ERRATA SHEET

This errata sheet presents, in ~~strike-through~~ and double-underline format, the revisions to the Initial Study/Mitigated Negative Declaration (IS/MND) for the Hanson Lane Project (proposed project). The revisions to the IS/MND reflected in this errata sheet do not affect the adequacy of the previous environmental analysis contained in the IS/MND. Because the changes presented below would not result in any new significant impacts or a substantial increase in the severity of an environmental impact identified in the IS/MND, recirculation of the IS/MND is not required.

Figure 3
Preliminary Site Plan (Revised)

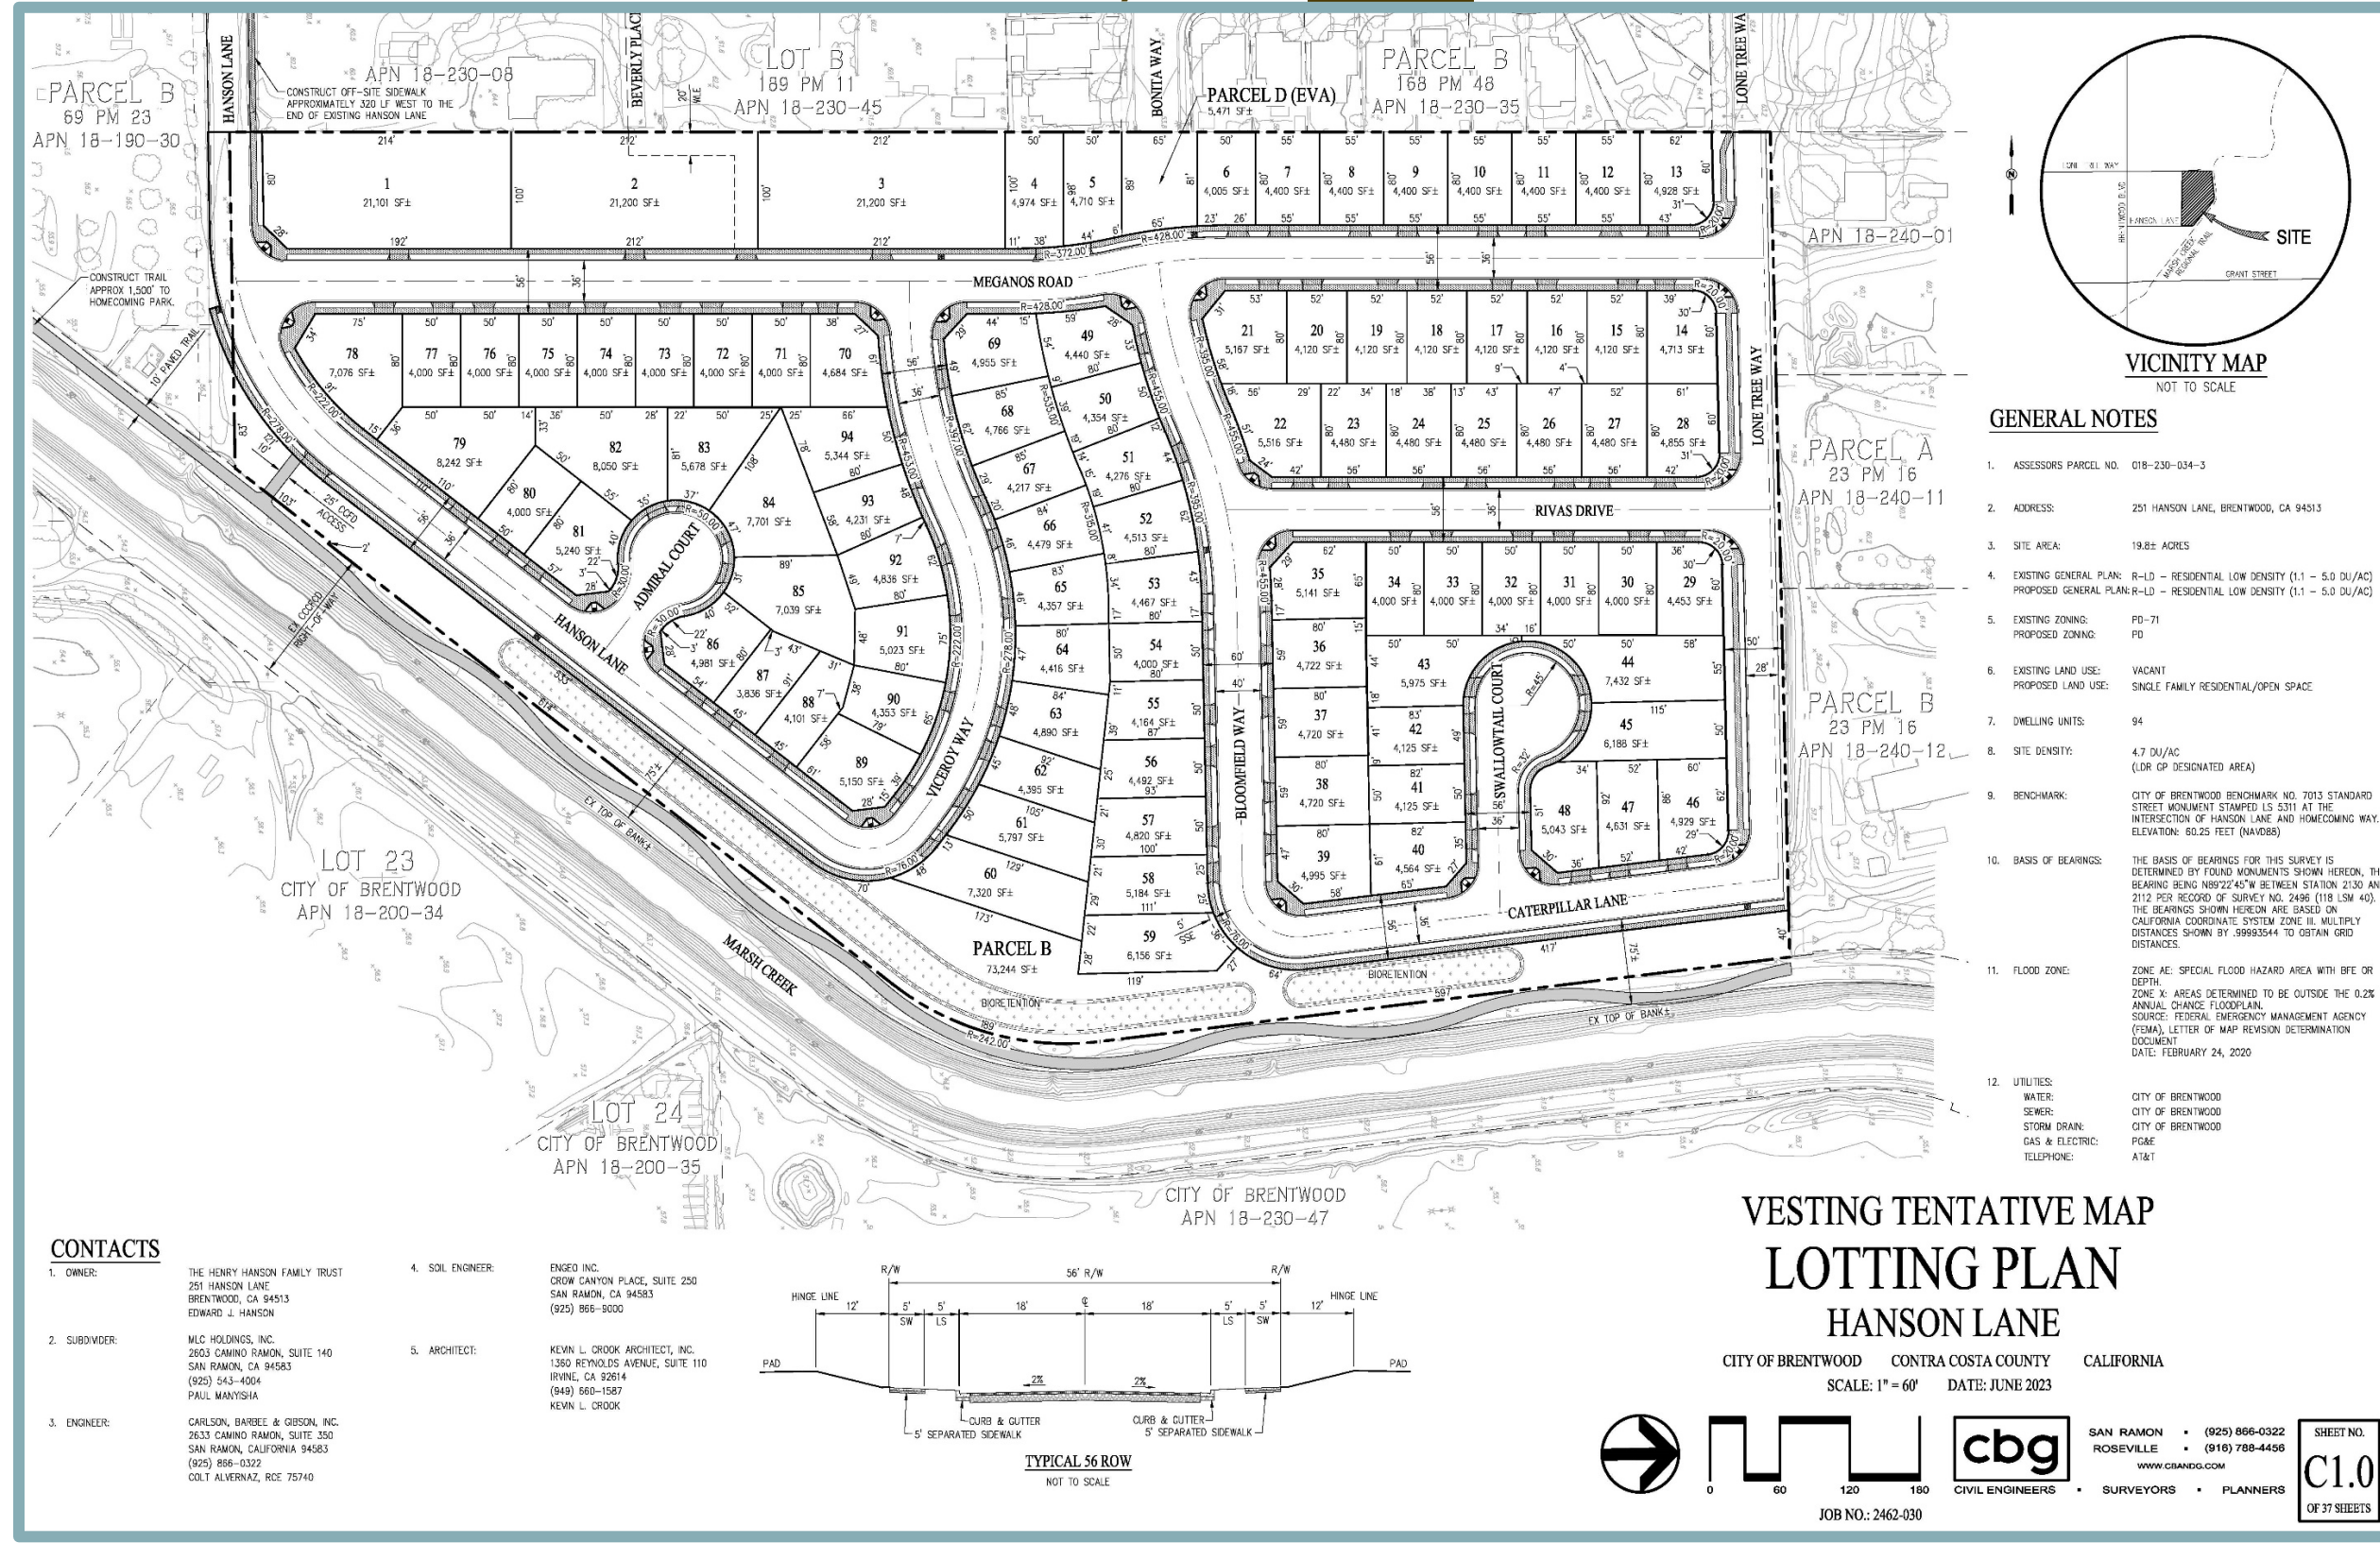
The site plan for proposed project has been revised since the IS/MND was circulated for public review to address City comments on the project plans and Density Bonus requirements. The changes to the site plan resulted in the removal of the 0.71-acre park site, addition of five single-family residences, and inclusion of an additional floor plan. The changes to the site plan did not alter the proposed internal roadways, driveways, emergency vehicle access lot, sidewalks, or landscaping.

The proposed project would include the subdivision of the site to develop ~~89~~ 94 single-family residences, consisting of ~~and~~ three estate residential lots ranging from 21,101 sf to 21,100 21,200 sf and 91 residential lots ranging in size from 4,000 sf to 8,242 sf (see Figure 3).

Figure 6
Proposed Floor Plan 3 (Revised)

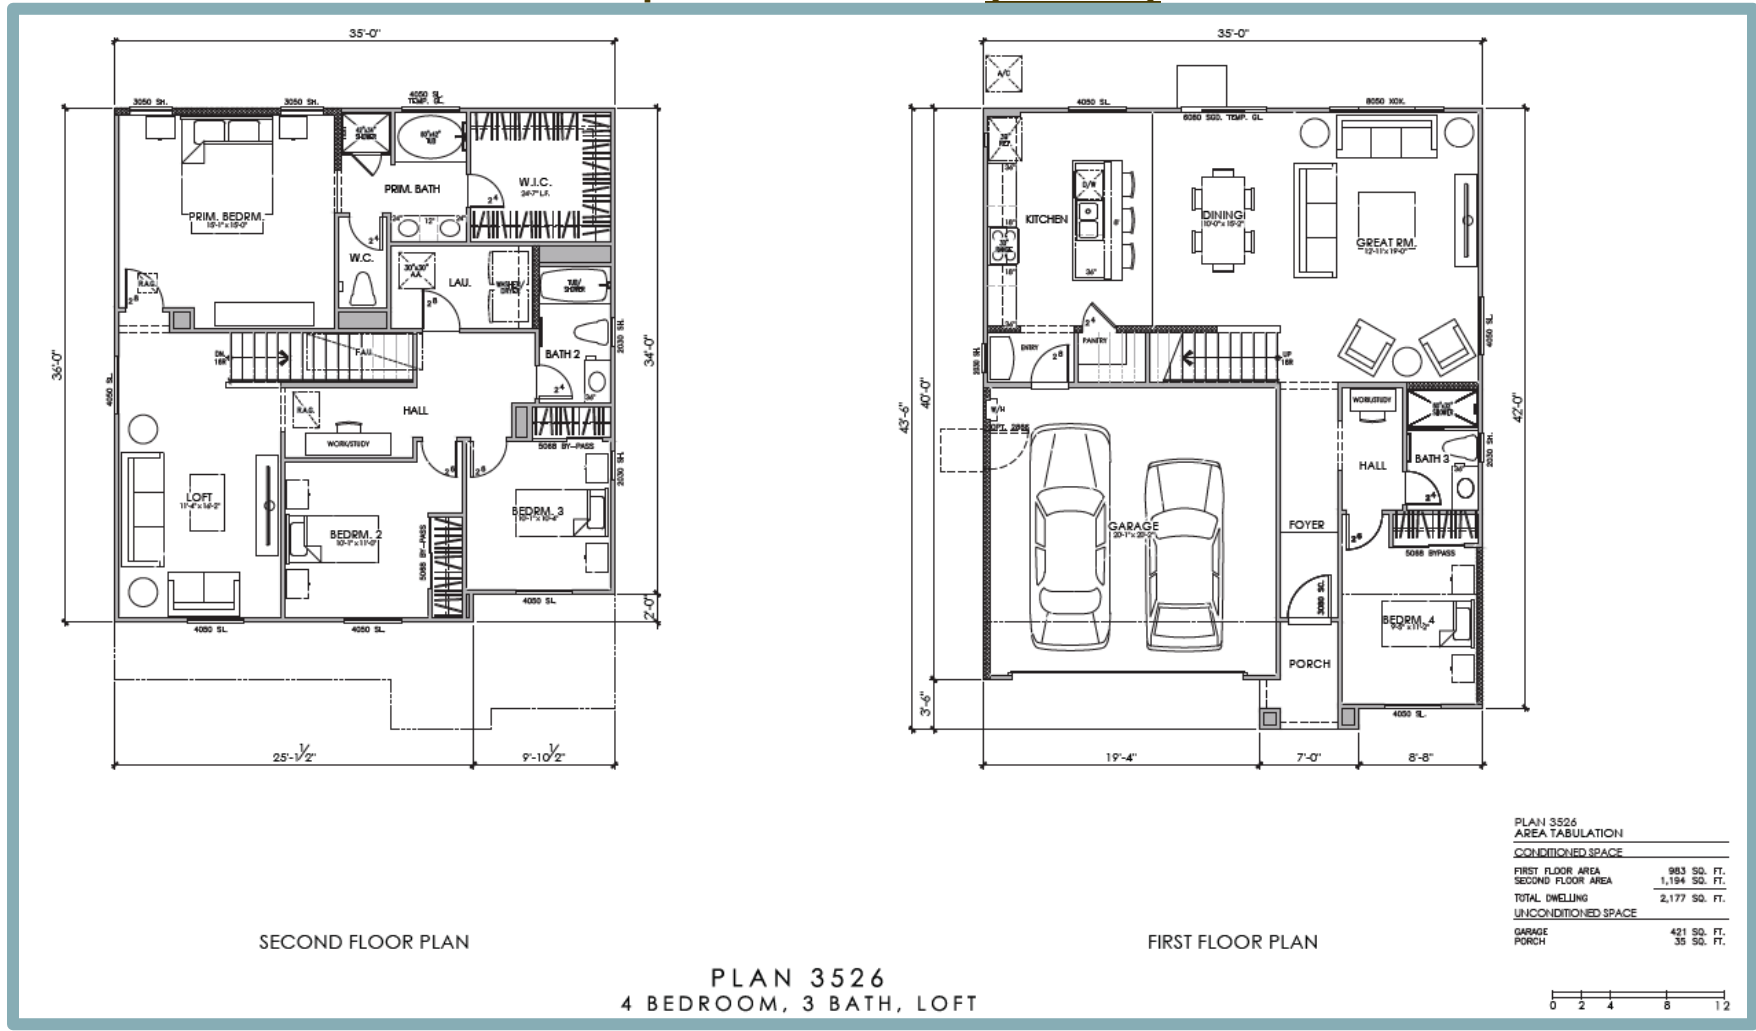
- ~~28~~ 24 lots would be developed according to Floor Plan 1 (see Figure 4) and would consist of a 1,628-sf residence with three bedrooms;
- ~~29~~ 23 lots would be developed according to Floor Plan 2 (see Figure 5) and would consist of a 2,320-sf residence with four bedrooms and a loft;
- 24 lots would be developed according to Floor Plan 3 (see Figure 6) and would consist of a 2,177-sf residence with four bedrooms and a loft;
- ~~29~~ 23 lots would be developed according to Floor Plan 43 (see Figure 76) and would consist of a 2,771-sf residence with four bedrooms, an office, and an optional fifth bedroom;
- ~~3 large lots along the western boundary of the site to be developed with floor plans 1, 2, or 3.~~

In accordance with the above, Figures 3, 6, 7, and 8 in the IS/MND are hereby replaced and/or revised as shown at the end of this Errata Sheet. The additional floor plan is hereby added as Figure 6, as shown at the end of this Errata Sheet. All subsequent figures in the IS/MND are hereby renumbered as appropriate. The above changes are hereby applied throughout the remainder of the IS/MND, as appropriate.

Figure 78
Landscaping Plan (Revised)

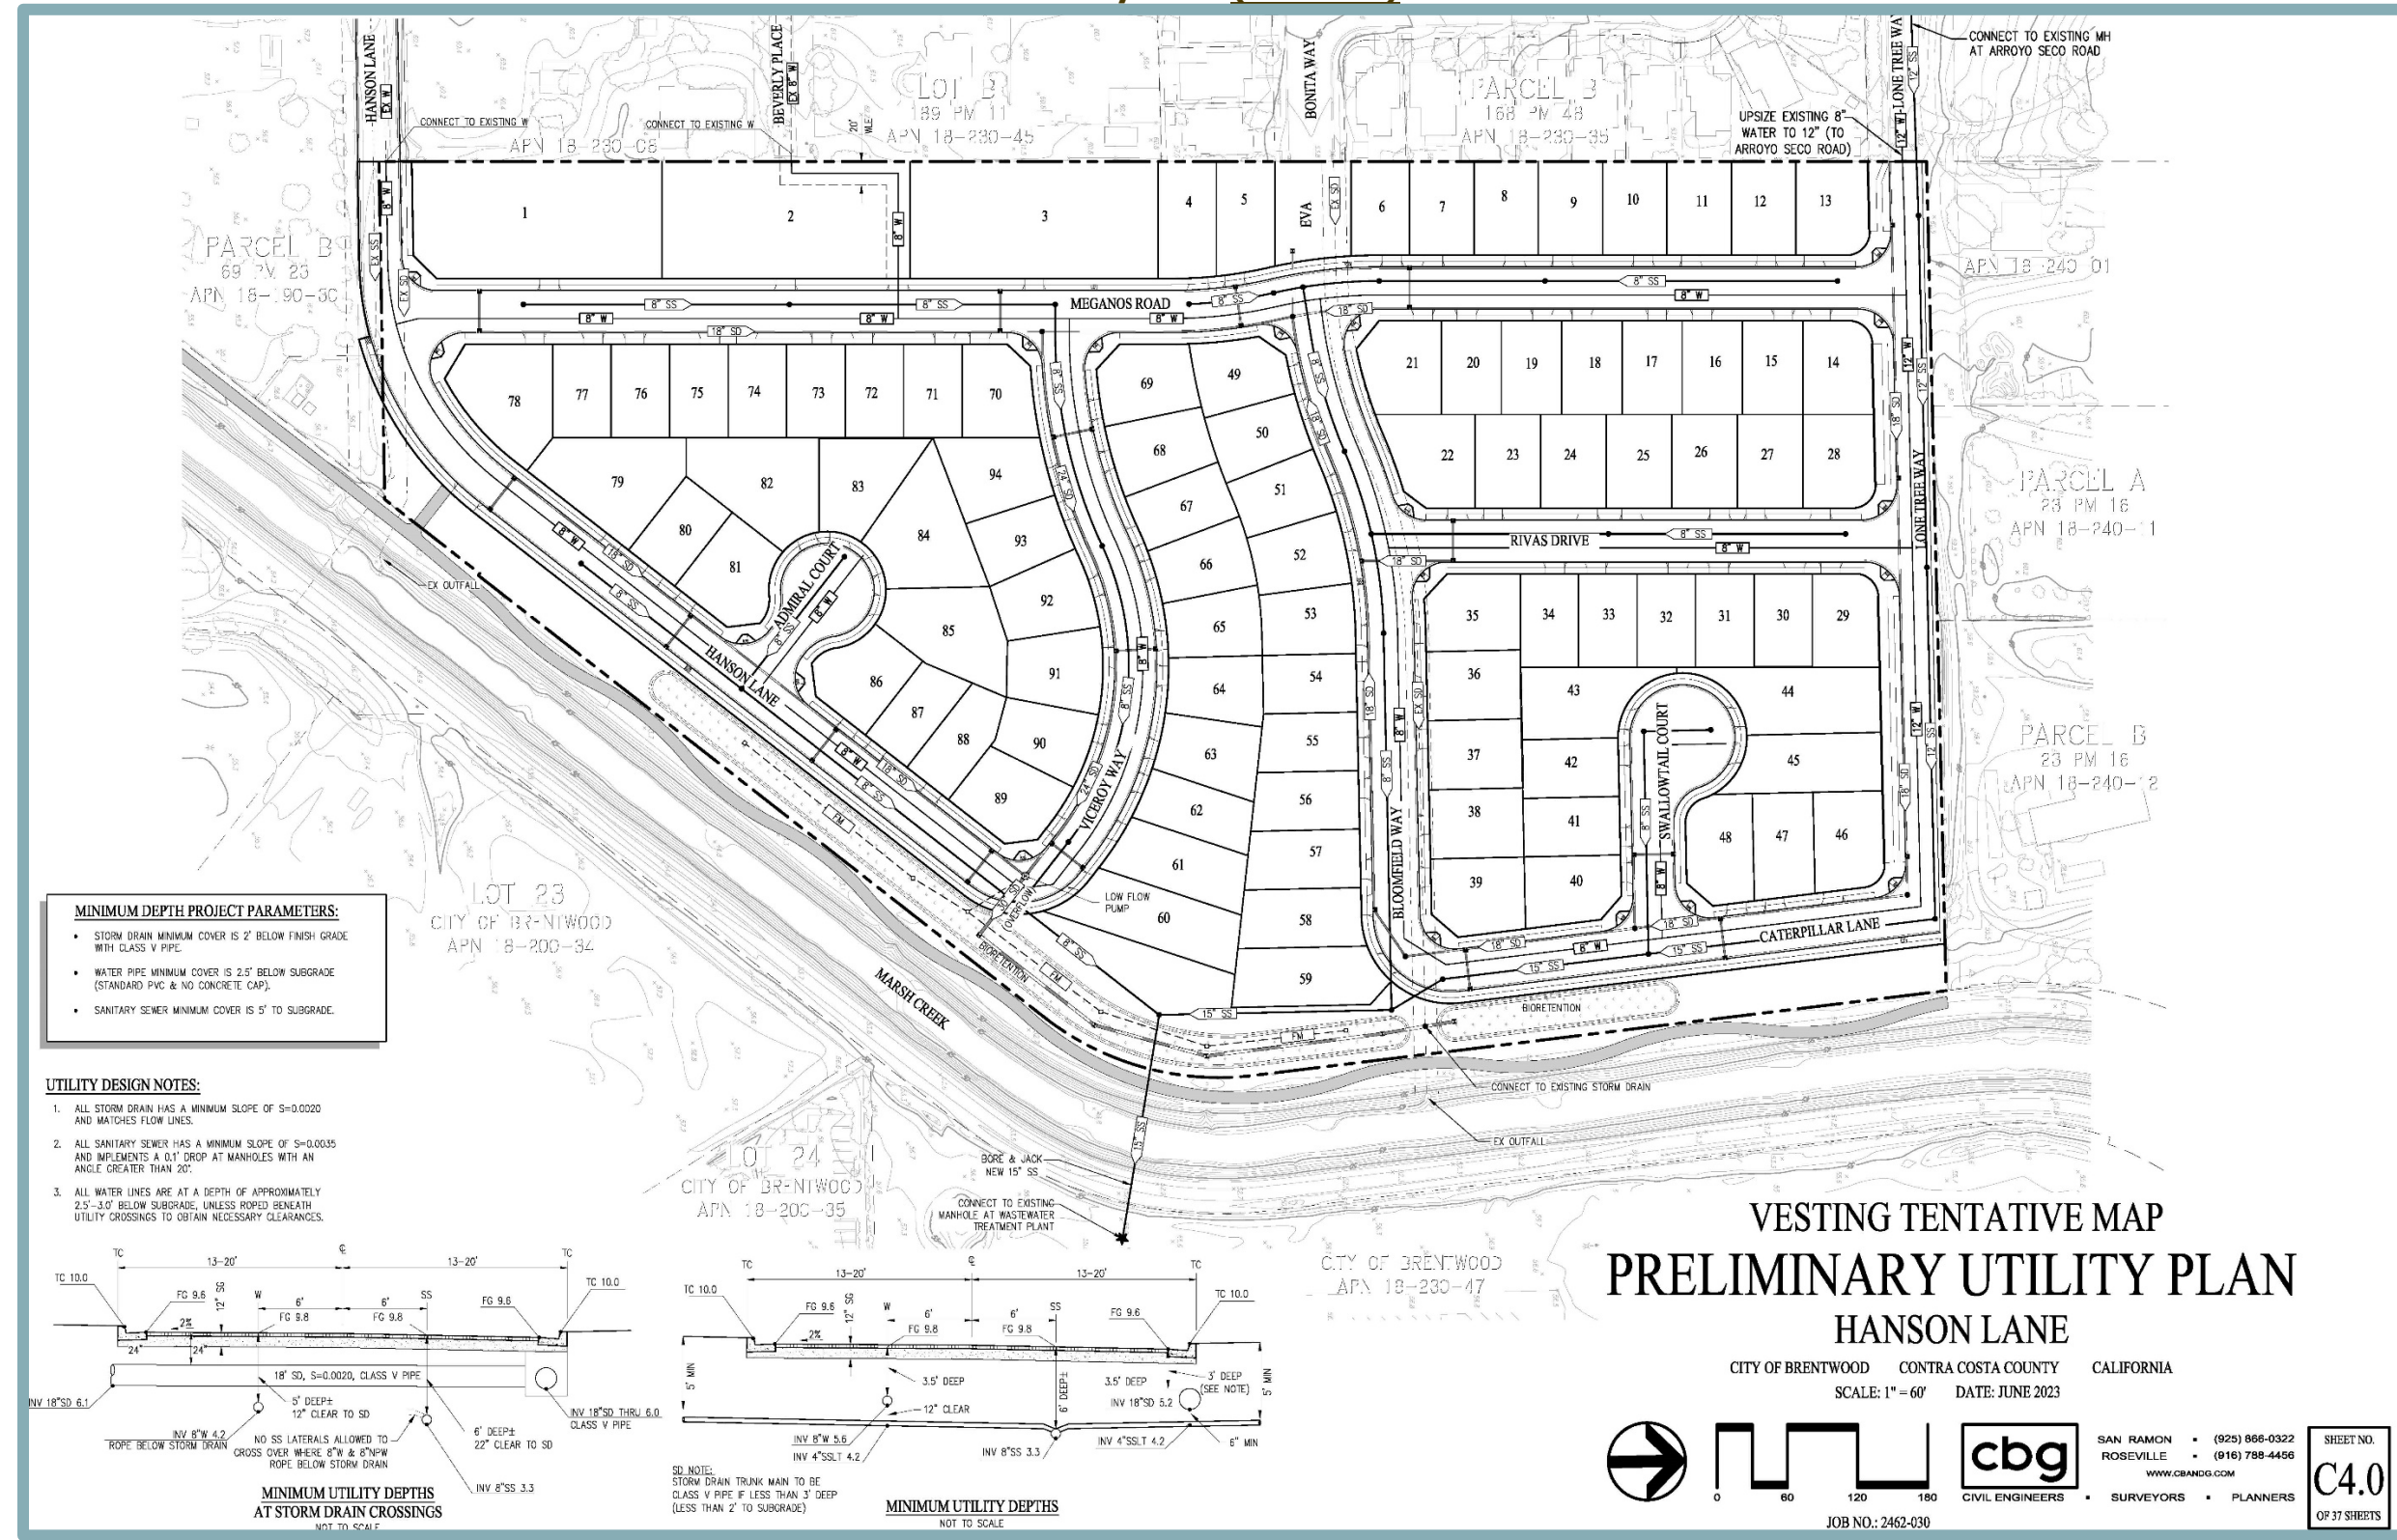
~~The proposed project would include a 0.71-acre park site along the eastern boundary of the project site (see Figure 7). The park would conceptually include a play structure and turf area, picnic tables, basketball court, park benches and barbecues. An open space area would be provided along the western side of Marsh Creek (see Figure 8). The open space area would connect to the proposed on-site sidewalks along Marsh Creek and would include turf, benches, and landscaping and sidewalks. All existing on-site trees would be removed as part of the proposed project; however, trees would be planted throughout the open space area park and along the internal roadway network within the project site. In addition, a variety of shrubs, groundcover, and grasses would be planted throughout the project site.~~
